Preliminary Change Request for the Chromatic Sextupoles and Trim Quadrupole Elements of the SNS Accumulator Ring

BNL/SNS TECHNICAL NOTE

NO. 075

May 30, 2000

Figure 1: Schematic layout showing dipole, quadrupole, sextupole, and corrector magnets of one lattice super-period. The chromatic sextupoles are shown in green.

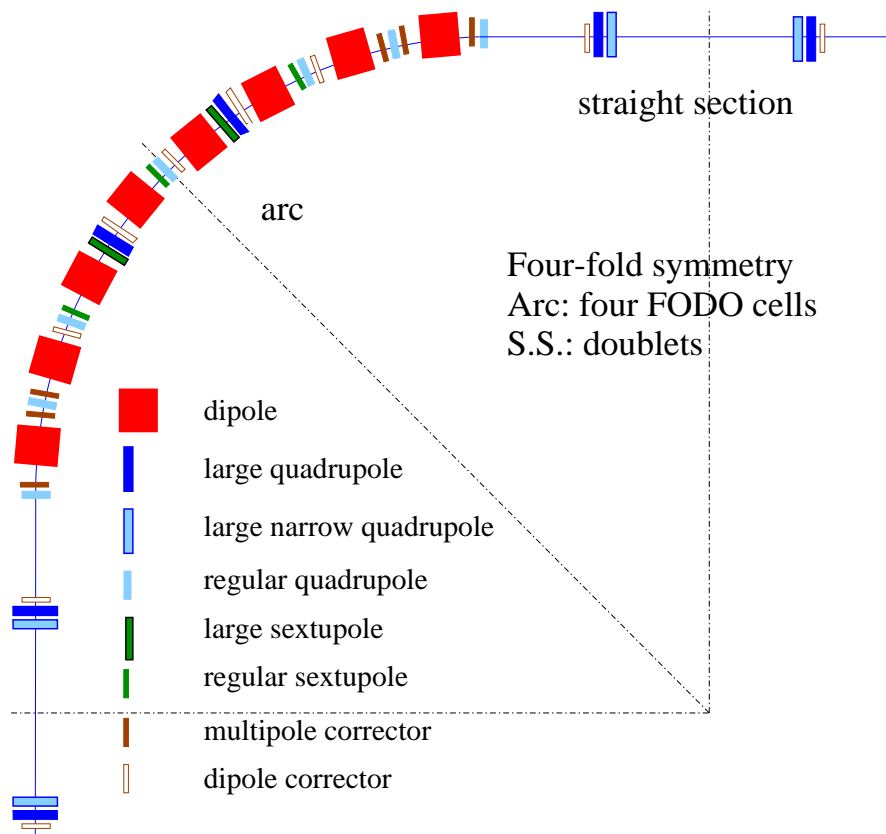
In the proposed lattice design, five chromatic sextupoles are placed downstream to the arc quadrupoles, at areas of large dispersion (Figs. 1 and 2). These “strong” sextupoles have been foreseen for adjusting the chromaticities to desired values, minimizing off-momentum optical mismatch and control resonance effects and instabilities [2].

Figure 3: Lattice functions of the SNS accumulator ring for the nominal tunes (6.3,5.8) using two families of sextupoles. The beta and dispersion functions are strongly perturbed for off-momentum cases.

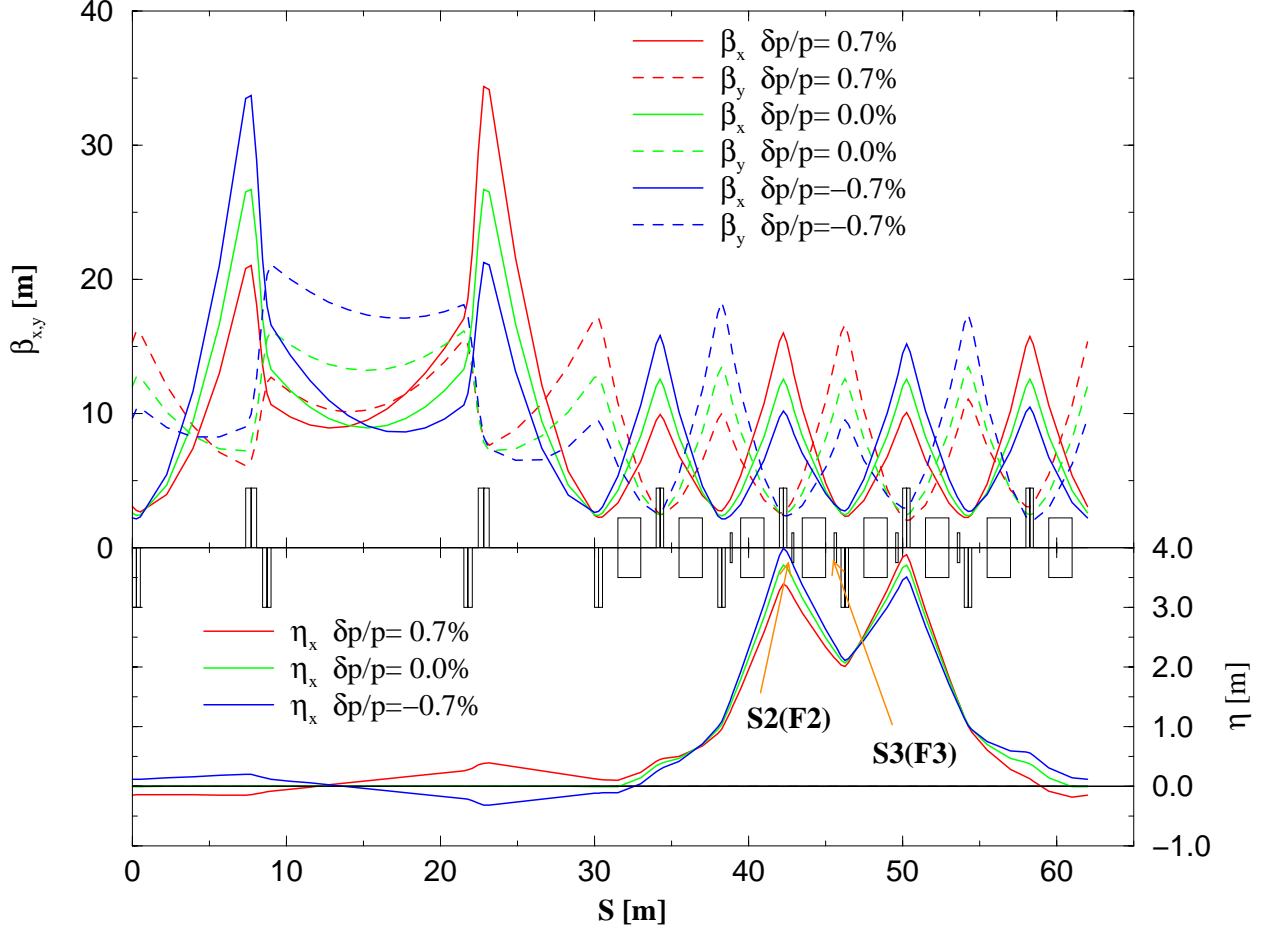
Two families of sextupoles, placed at high-beta and high-dispersion regions, can control the linear chromaticity of the ring. The sextupoles however may strongly affect the first and second order of the beta and dispersion functions dependence on the momentum spread, introducing strong “beta/dispersion waves” and, thereby, reducing the dynamic aperture. In addition, this beta/dispersion variation will increase the first and higher order terms of the chromaticity. This is clearly shown in figure 3: with a two-family scheme, the optical distortion in β -function is as large as 30% for off-momentum orbits.

Figure 4: Lattice functions of the SNS accumulator ring for the nominal tunes (6.3,5.8) using 4 families of sextupoles. The beta and dispersion wave has been minimized by the introduction of the 2 supplementary sextupole families.

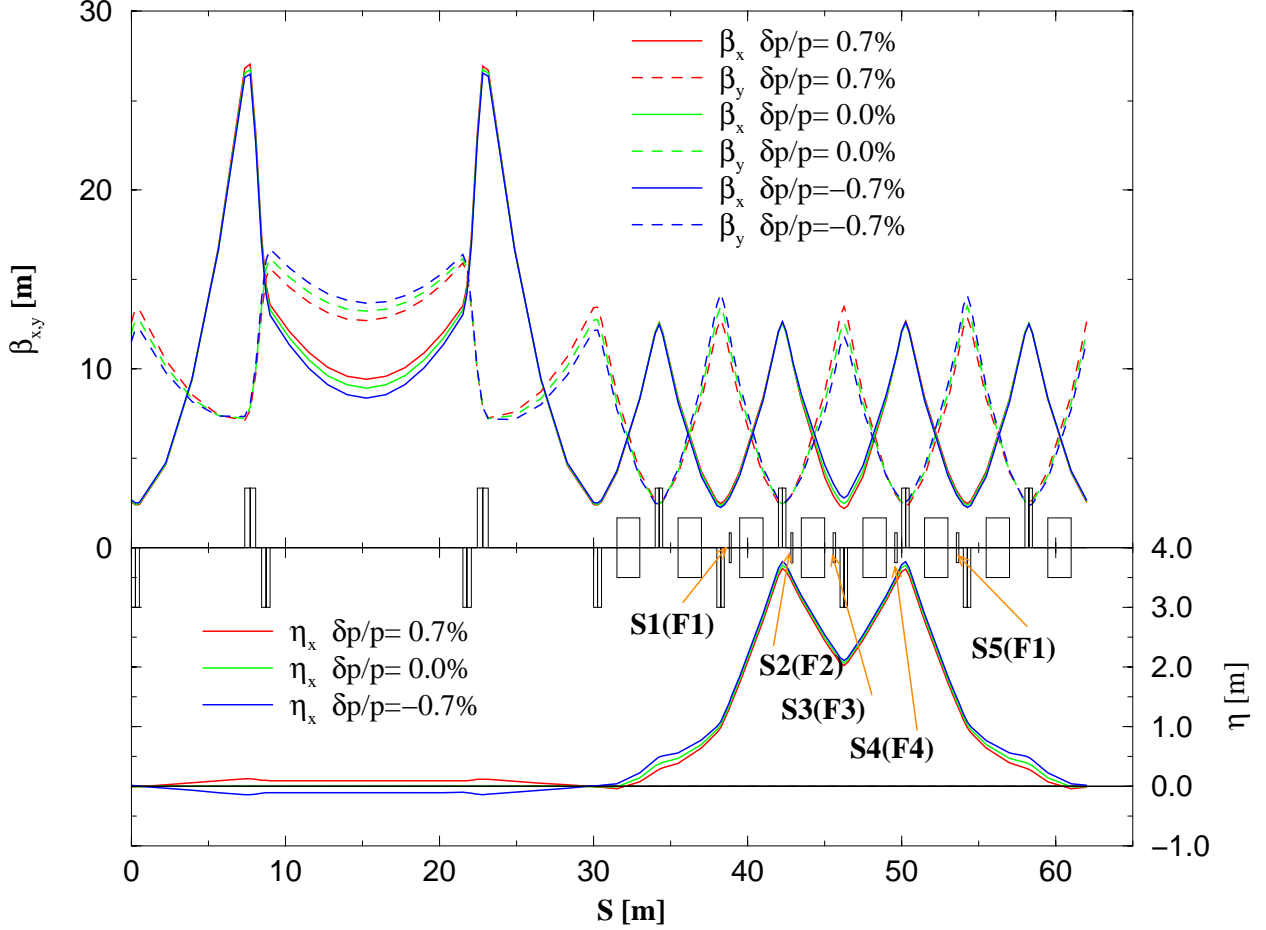
In order to minimize the dependence of the beta, the dispersion functions and the chromaticity on $\delta p/p$, additional families of sextupoles are required. In the proposed chromaticity correction scheme, three of the sextupoles are powered independently and two of them in

series, forming a total of four families. With a four-family scheme, the off-momentum optics is greatly improved, and the β -wave is minimal (Fig. 4).

Figure 5: Sextupole strengths for the four families of chromatic sextupoles versus the chromaticity. The maximum values are within the strength requirements (Table 2.1).

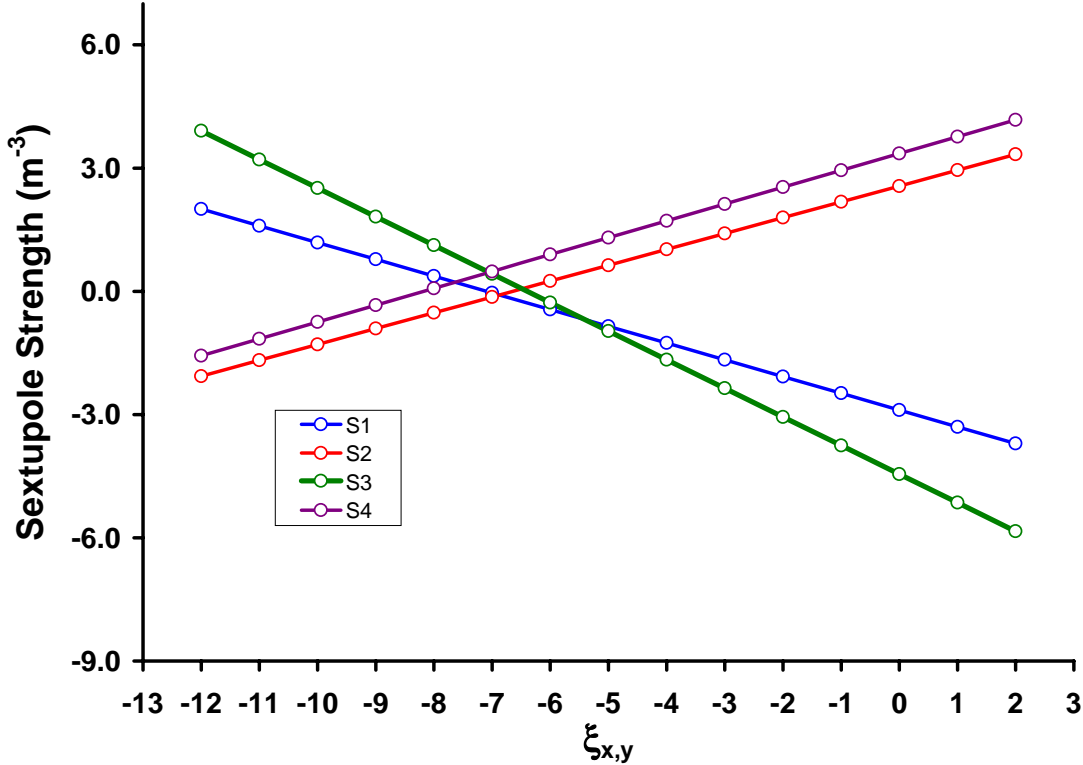
By using the HARMON module of the MAD program [4], we have computed the required strength of the four families of sextupoles in order to adjust the horizontal and vertical chromaticity $\xi_{x,y}$ to a wide value range and at the same time to minimize the optics functions' perturbation (Fig. 5). We observe that the sextupole strengths for the most extreme cases are less than 6m^{-3} . Thus, the strength requirements of 8.3m^{-3} , given in Table 2.1, are sufficient to handle the chromaticity/optics control, leaving a comfortable 20% margin.

Figure 6: Anharmonicities versus the chromaticity. The maximum values are within 5% of the ones produced by the quadrupole fringe-fields.

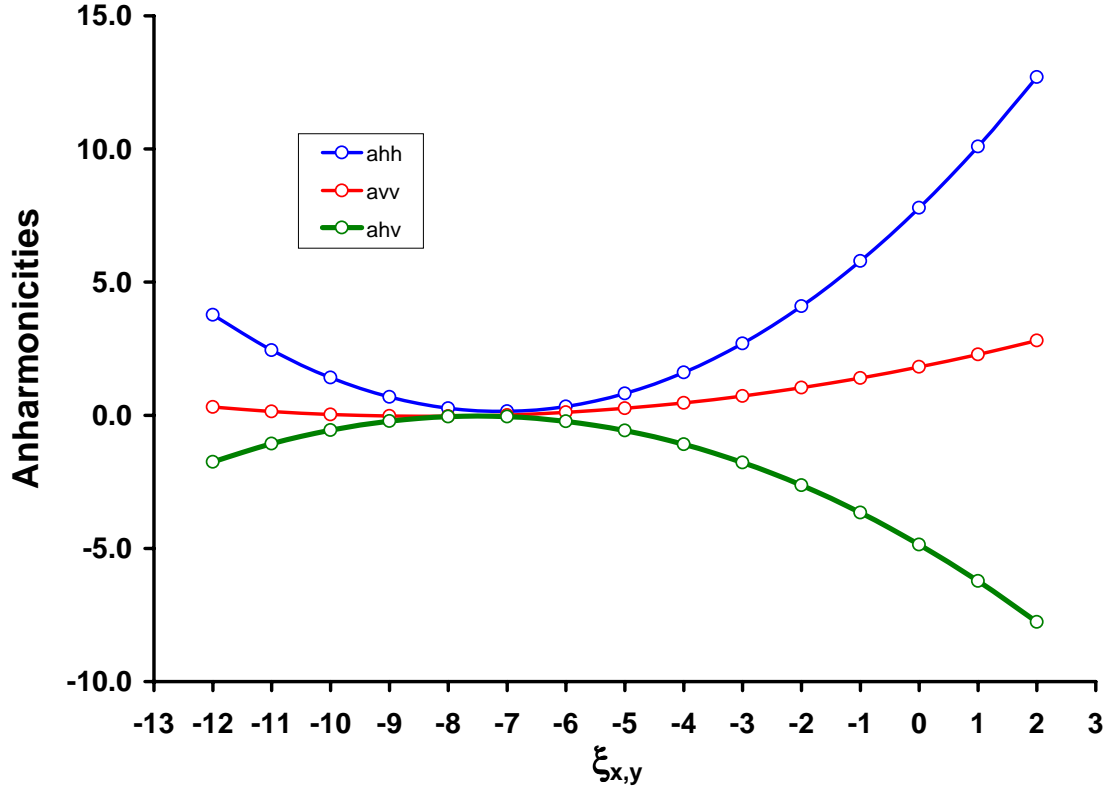
three quantities have been computed for all range of chromaticity values and plotted Fig. 6. The maximum anharmonicity values are found to be a factor of five smaller than the ones introduced by the quadrupole fringe-fields [5], indicating that the introduction of chromatic sextupoles will not have an important non-linear impact on the SNS ring. This residual octupole-like tune-shift can be corrected by dedicated octupole correctors [5]. Additional tracking studies are in progress in order to further justify the small impact of the chromatic sextupoles in the non-linear dynamics of the SNS ring.
